Amendment to the Application to the
North Dakota Public Service Commission
for
Consolidated Certificate of Corridor
Compatibility and Route Permit

Case No: PU-11-696

**AVS-Neset 345-kV
Transmission Project**

January 2015

Basin Electric Power Cooperative
Antelope Valley Station to Neset
345-kV Transmission Project
Route Change Maps
Sheet 1 of 1

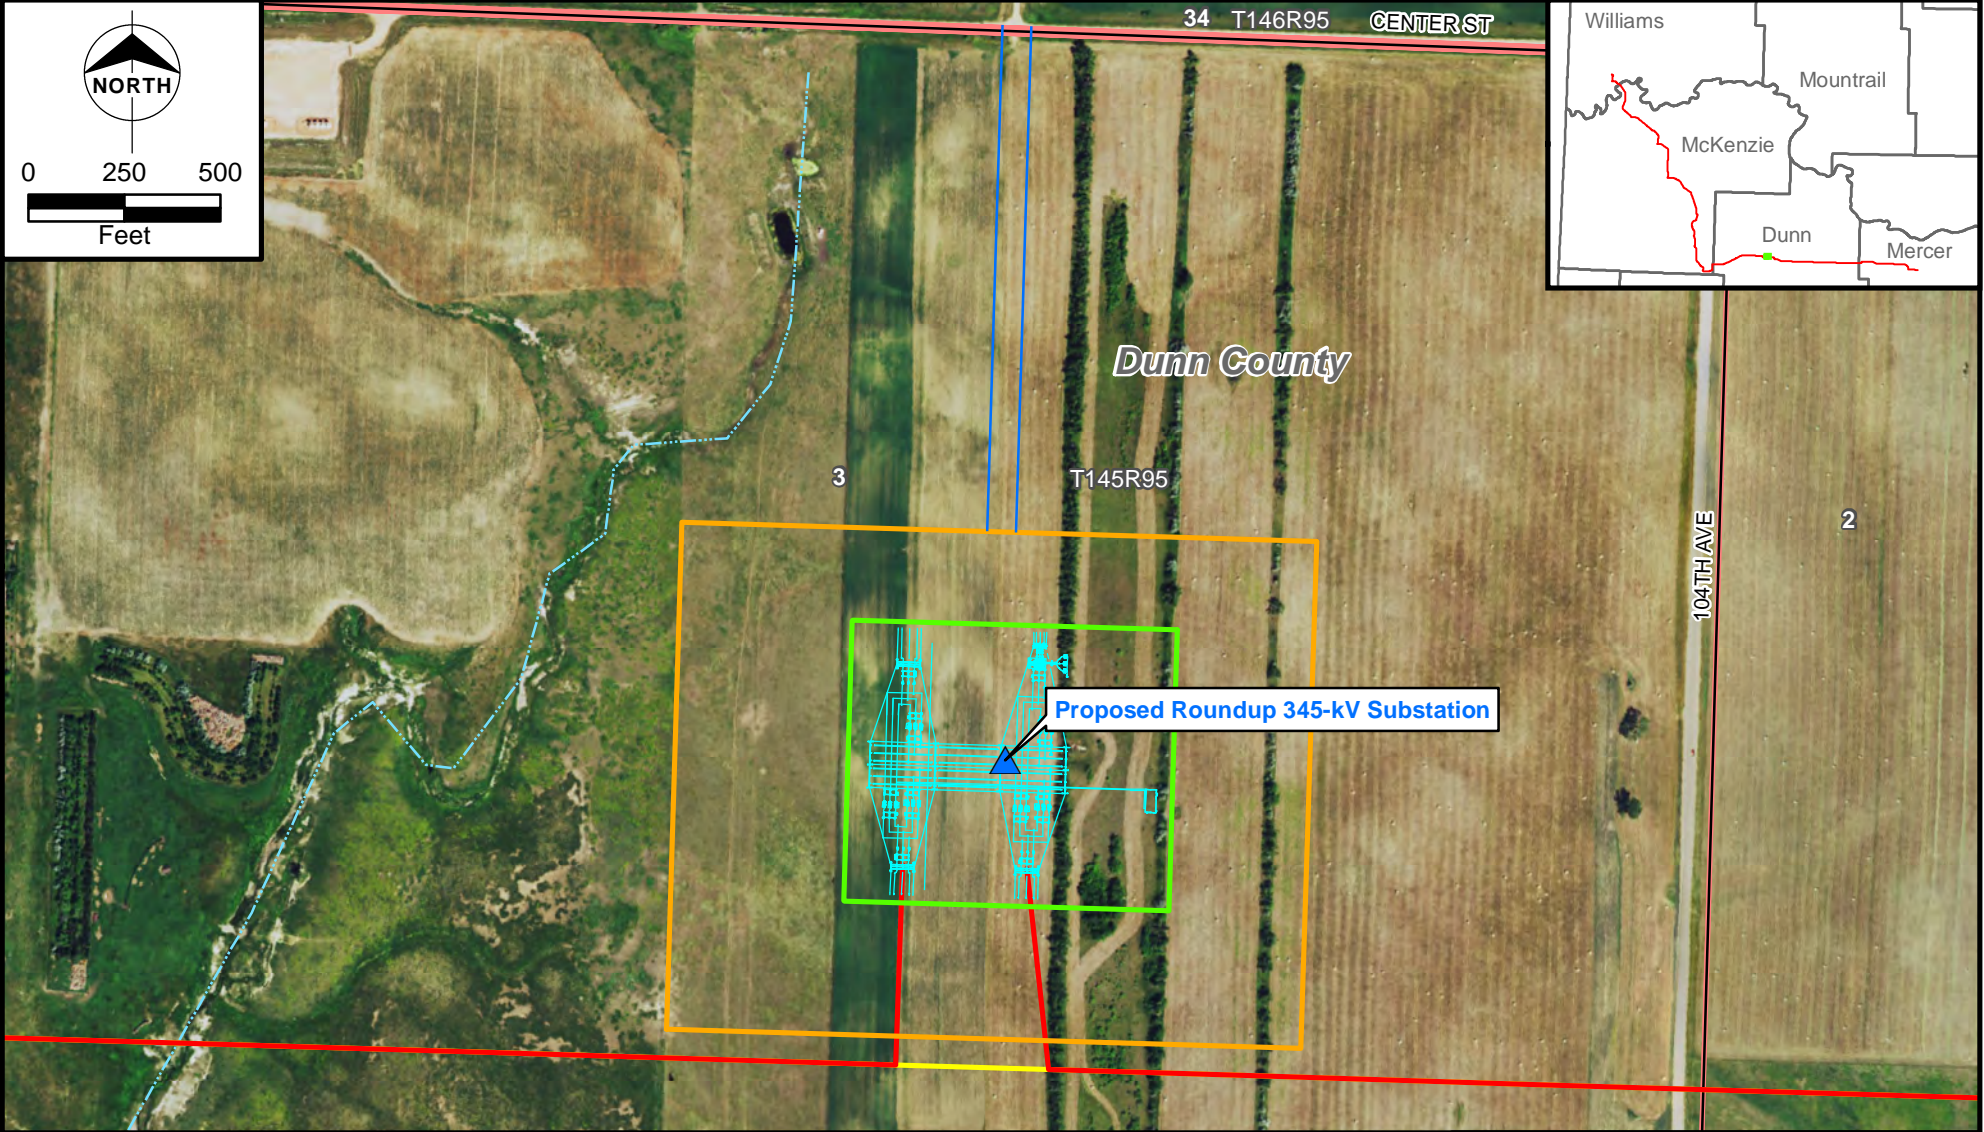
The addition of the proposed Roundup Substation does not significantly alter the information presented in the original application. Only siting criteria information that has changed because of the addition of the substation to the Project is presented in this amendment. All other sections of the original application and the March 2013, July 2014, and December 2014 Amendments remain in effect. The general location and reason for the Corridor/Route change are summarized in the following table, and the change is illustrated on the Corridor/Route change map following Table 1.0-1.

Township	Range	Section	Reason	Route Change Map Sheet #
145N	95W	3	New 345/115-kV load-serving substation (Roundup Substation)	Sheet 1

Figure 1.2-1
 Basin Electric Power Cooperative
 Antelope Valley Station to Neset
 345-kV Transmission Project
 Overall Proposed Project Area and
 Proposed Corridor/Route

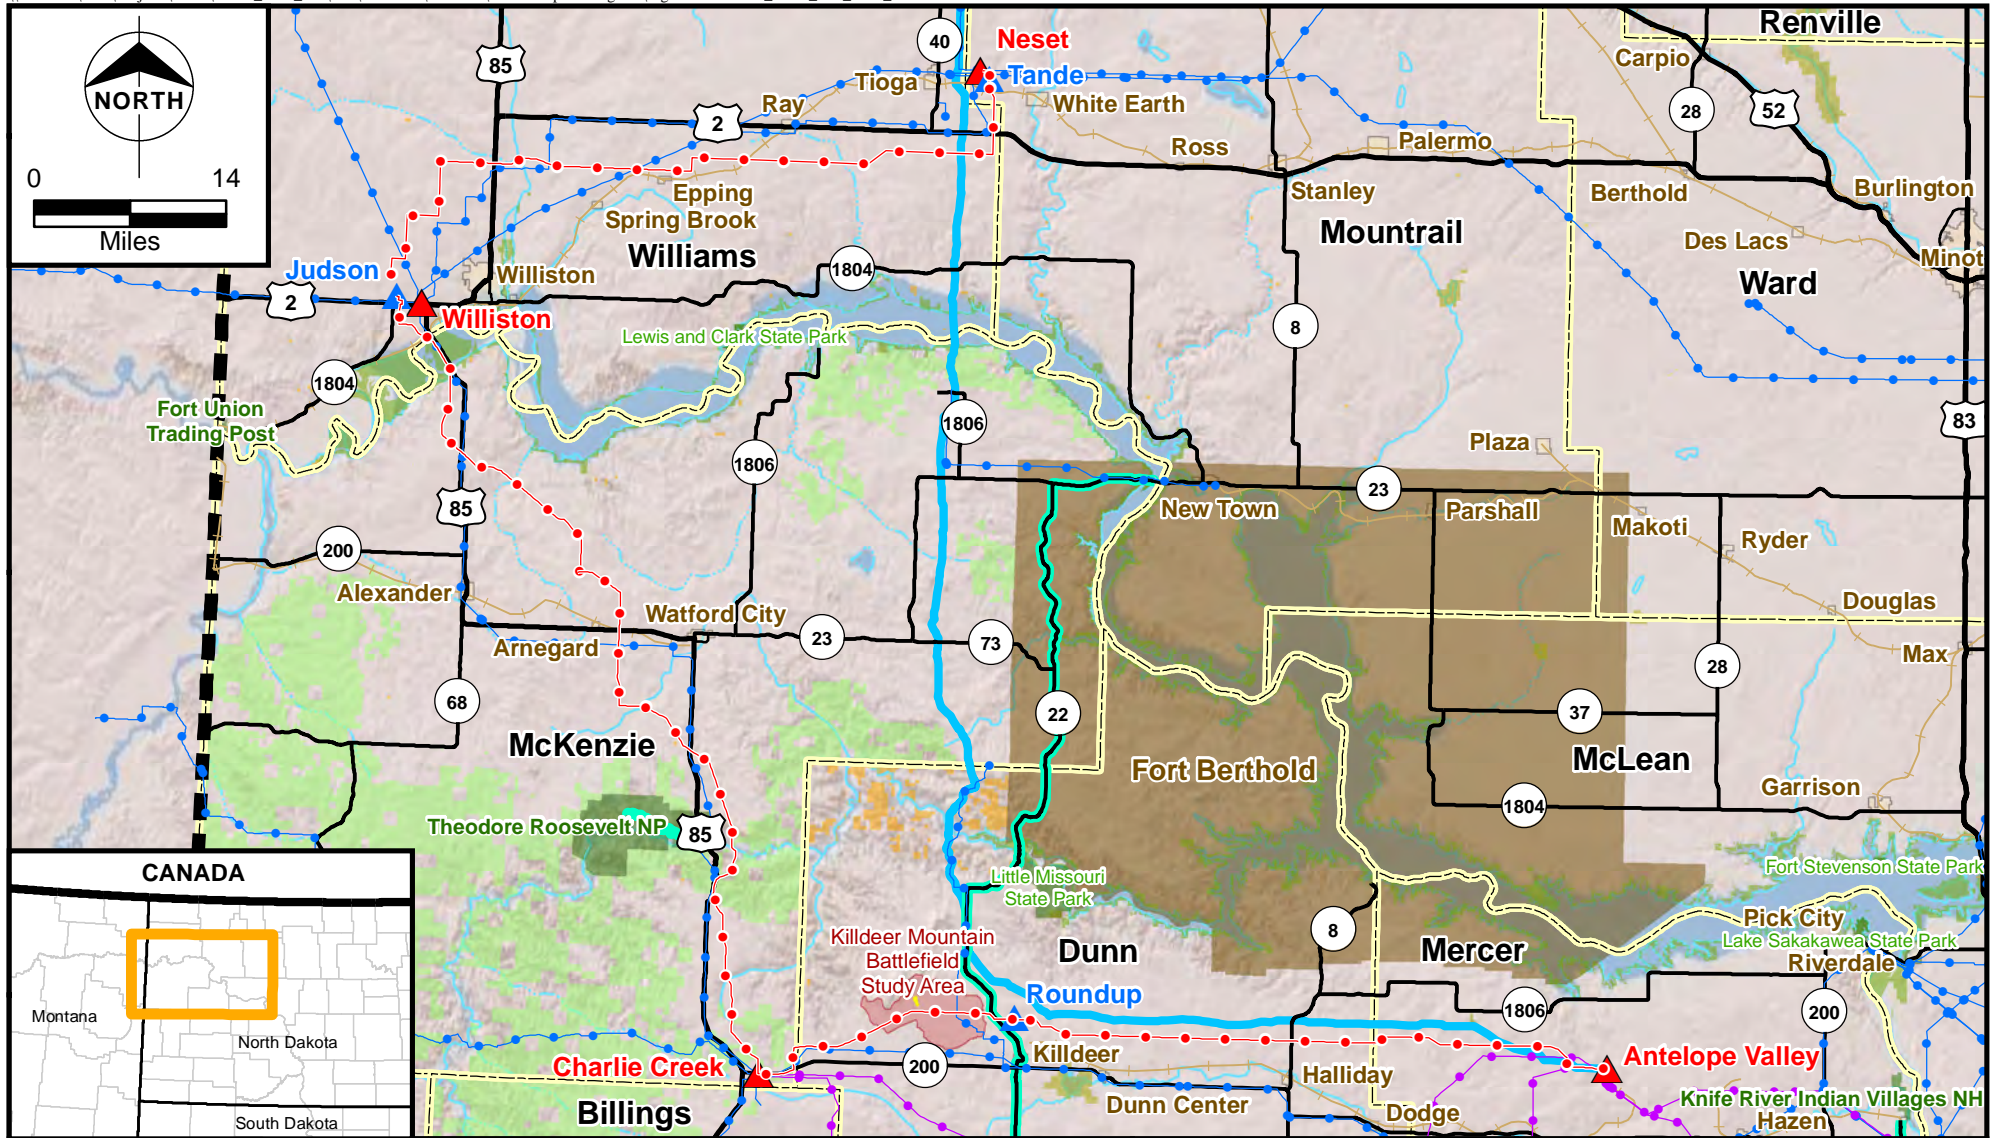
No changes from addition of proposed Roundup Substation. Figure 1.2-1 updated to include the proposed Roundup Substation.

Figure 1.4-1
Basin Electric Power Cooperative
Antelope Valley Station to Neset
345-kV Transmission Project
Future Associated Facilities

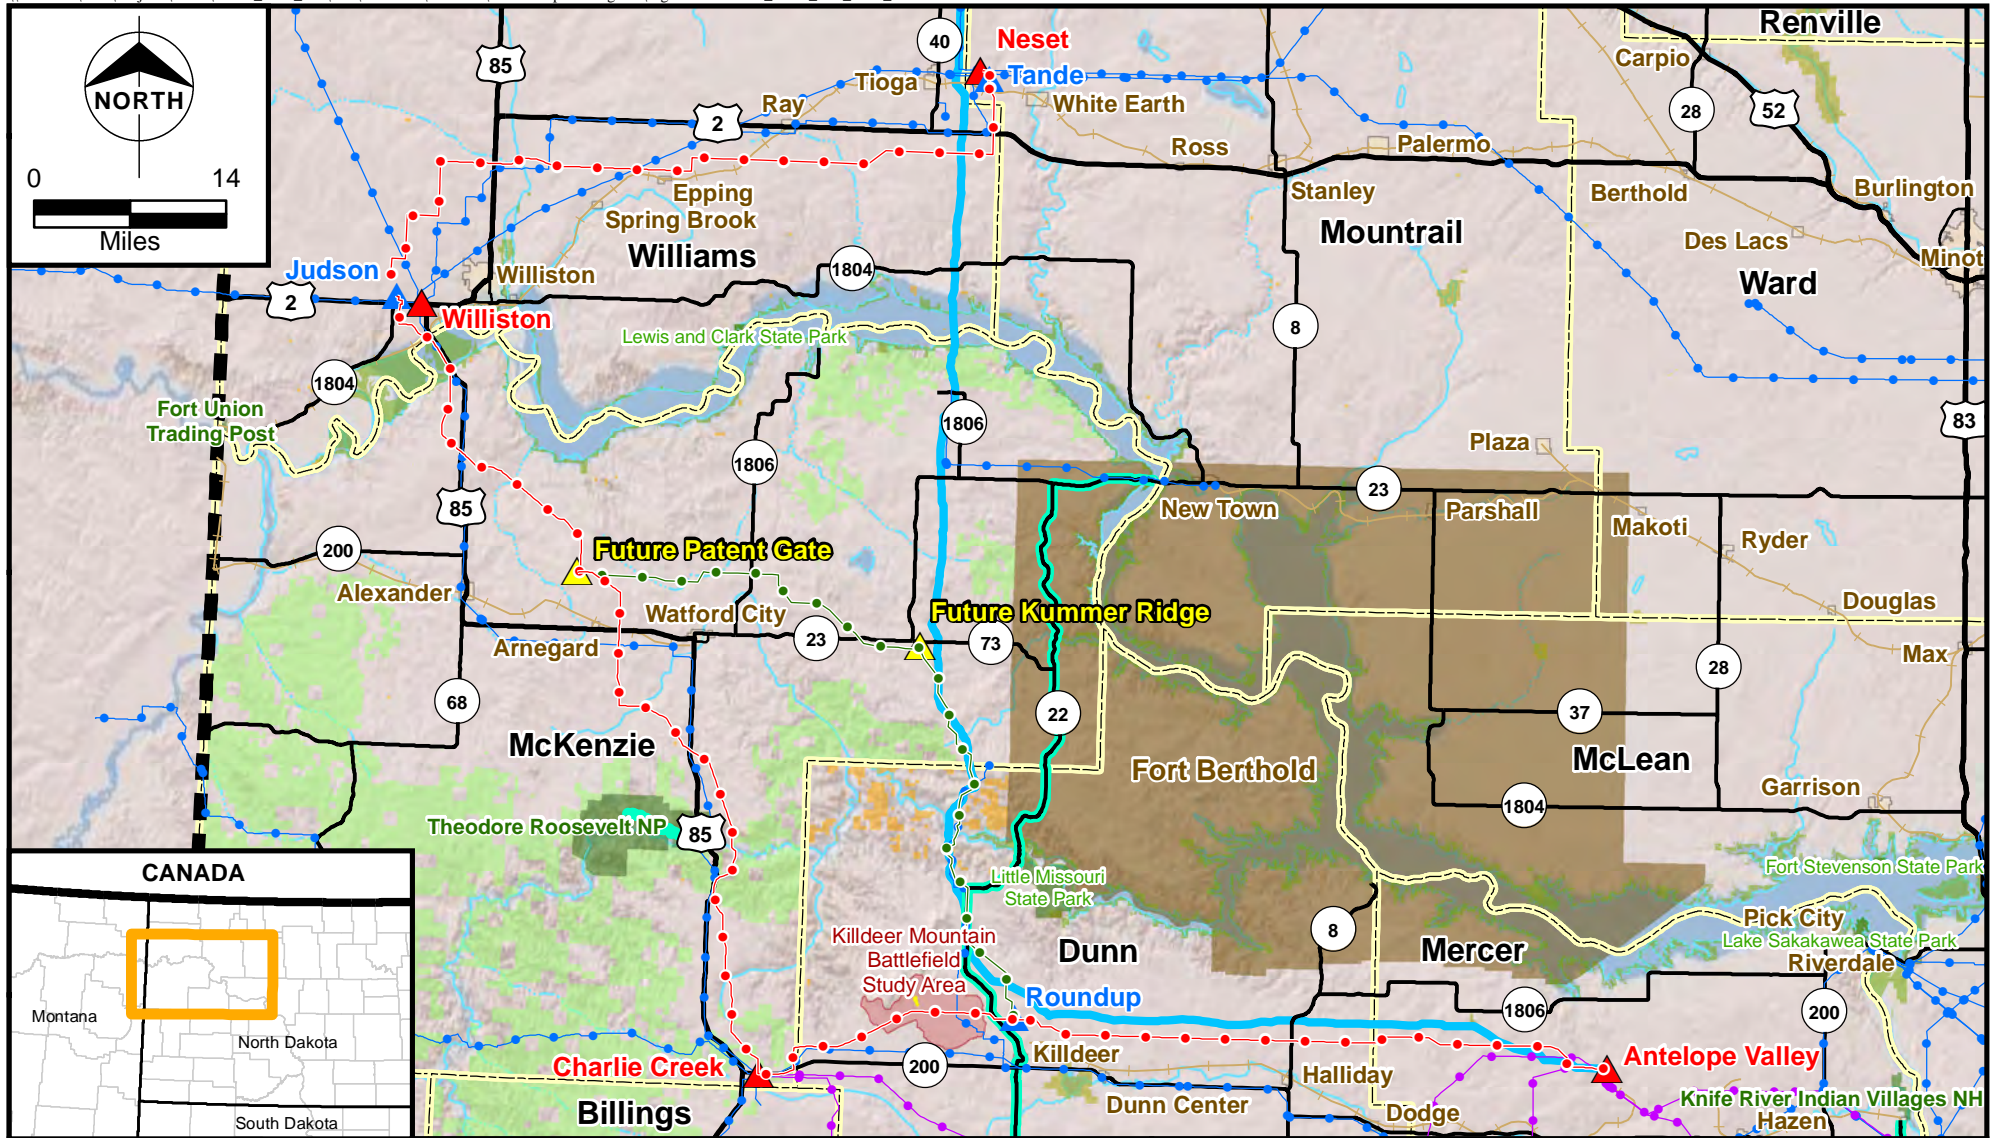
No changes from addition of proposed Roundup Substation. The future facilities identified in the July 2014 Amendment, including the North Killdeer Loop 345-kV transmission line (Phase I) and Patent Gate and Kummer Ridge 345/115-kV substations are addressed in a separate Application, Docket # PU-14-831. Figure 1.4.1 has been updated to include the Roundup Substation.

Figure 4.2-5
Basin Electric Power Cooperative
Antelope Valley Station to Neset
345-kV Transmission Project
Temporary Construction Material
and Equipment Laydown Areas

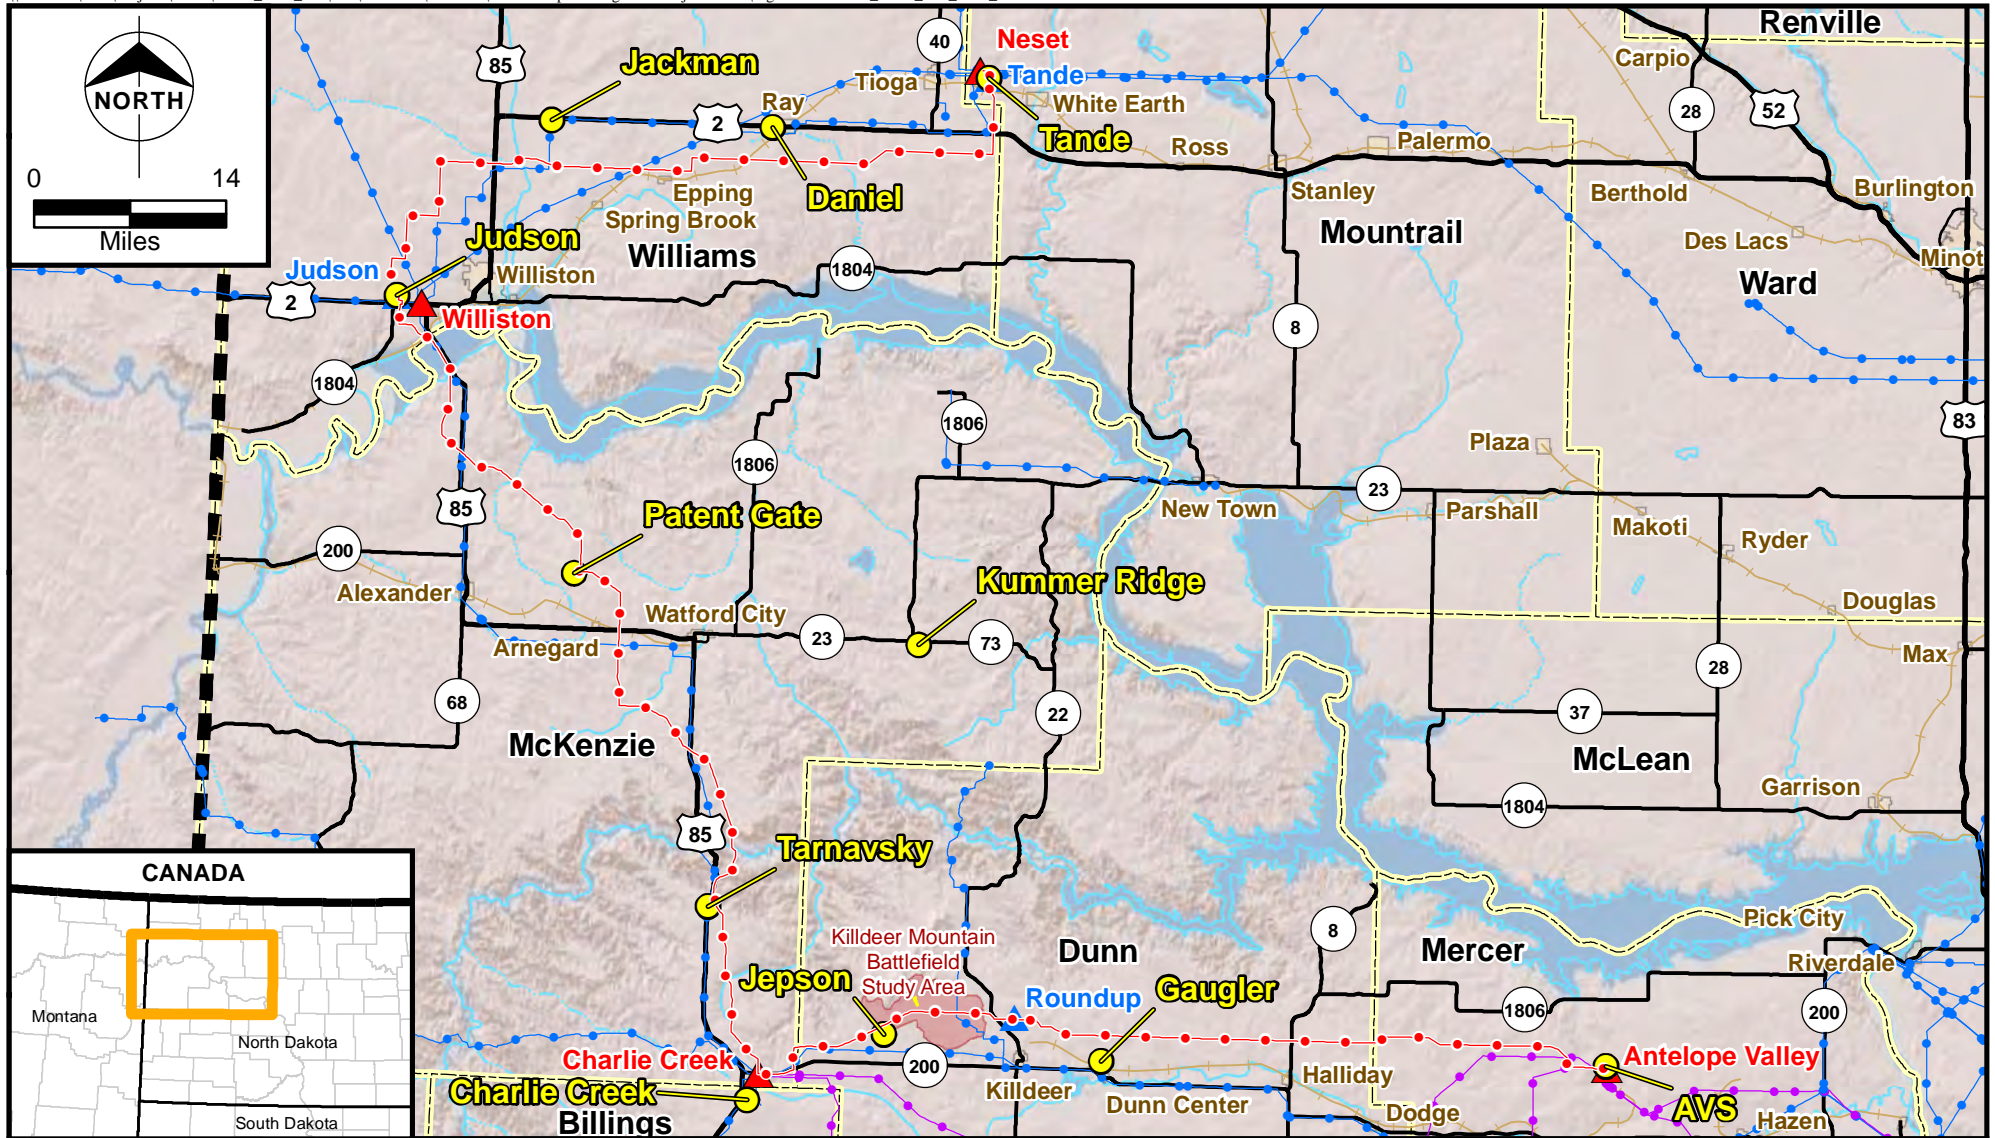
No changes from addition of proposed Roundup Substation. Figure 4.2-5 updated to include the Roundup Substation.
